COMPANY: Electronics Tomorrow Ltd.			
MODEL: 383A			
PCB VER: T2.0	TITLE: S.C.H	DDC VER: 00	
DRN./DATE: FWD 1/06	DWG NO.: 838AED0131		
CHK./DATE:	C: TM8706-K400 (838A)		
APP./DATE:	LCD:		
☒ TO FILE ☐ REL		SHEET 0F:1 OF 1	
EE005

COMPANY: Electronics Tomorrow Ltd.				
MODEL:		4670/1		
PCB VER:	79661V2.0	TITLE:	SCH	DOC VER: 00
DRN. /DATE: FWD 12/05		DWG NO: 4670E10431		
CHK. /DATE:		IC: RX3310A		
APP. /DATE:		LCD:		
☒ TO FILE		☐ REL		SHEET OF: EE005

COMPANY: Electronics Tommorrow Ltd		
MODEL: 4570/1		
PCB VER: v1.0	TITLE: SCH	DOC VER: 00
DRN./DATE: FWD 8/05	DWG NUM: 4570E10631	
CHK./DATE:	IC: MAS9180A1	
APP./DATE:	LCD:	
☒ TO FILE ☐ REL	SHEET 1 OF 1

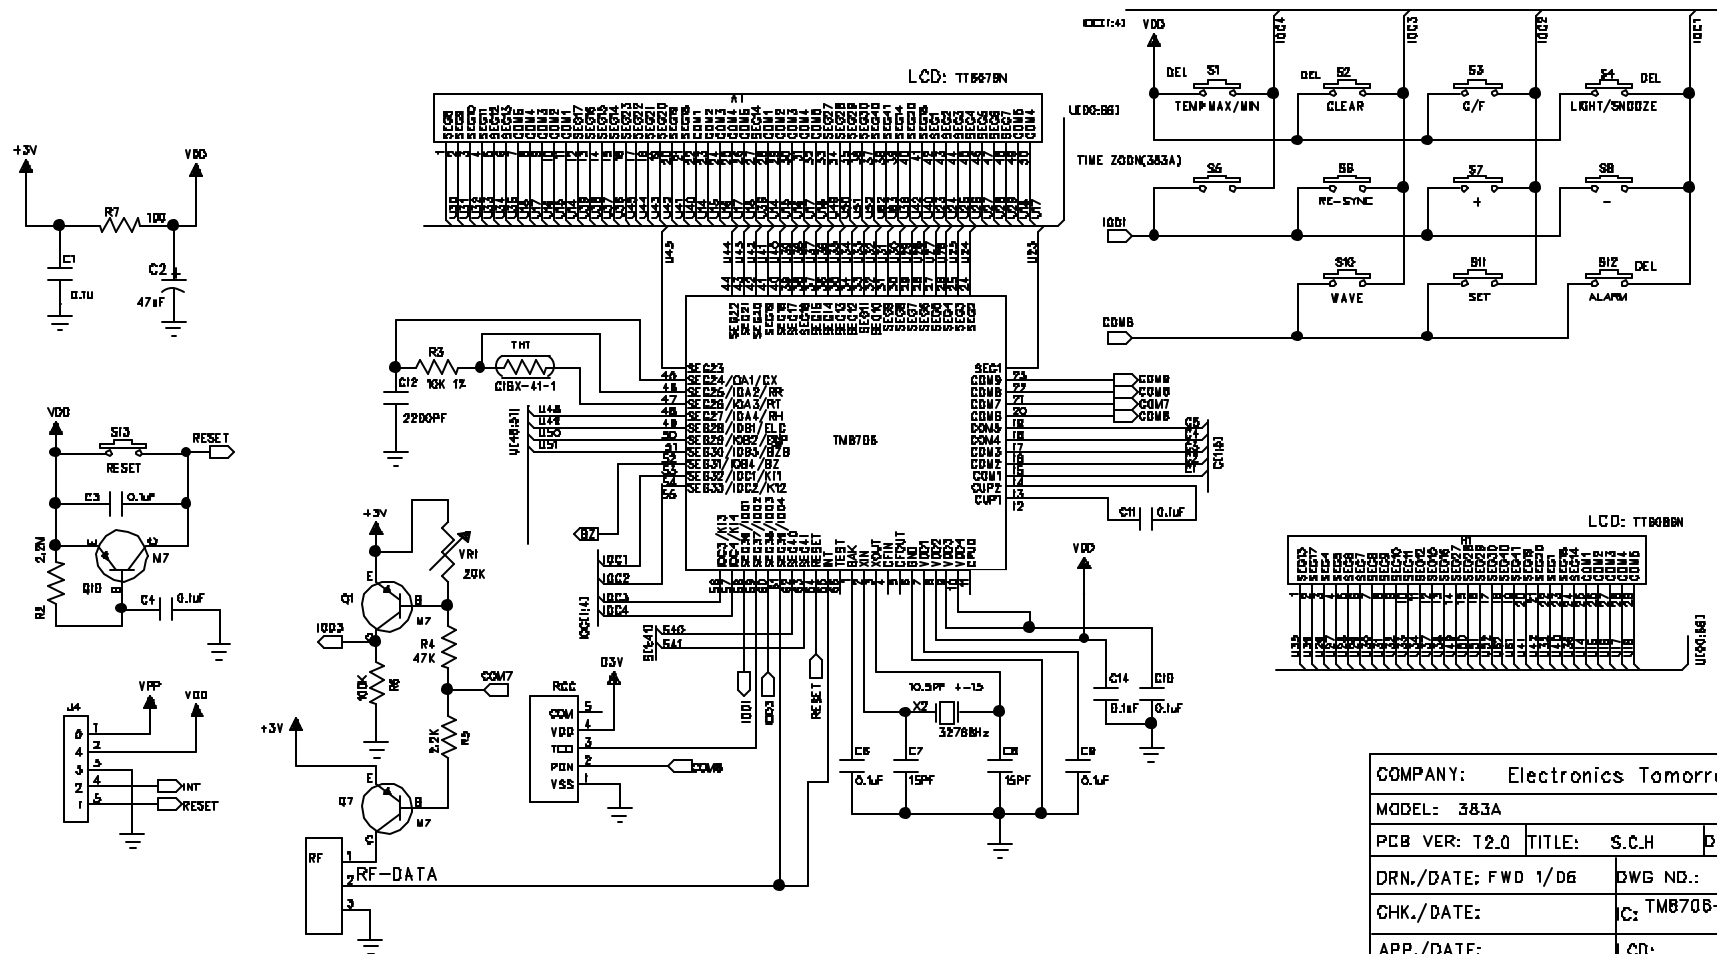
The substrate of chip should be connected GND
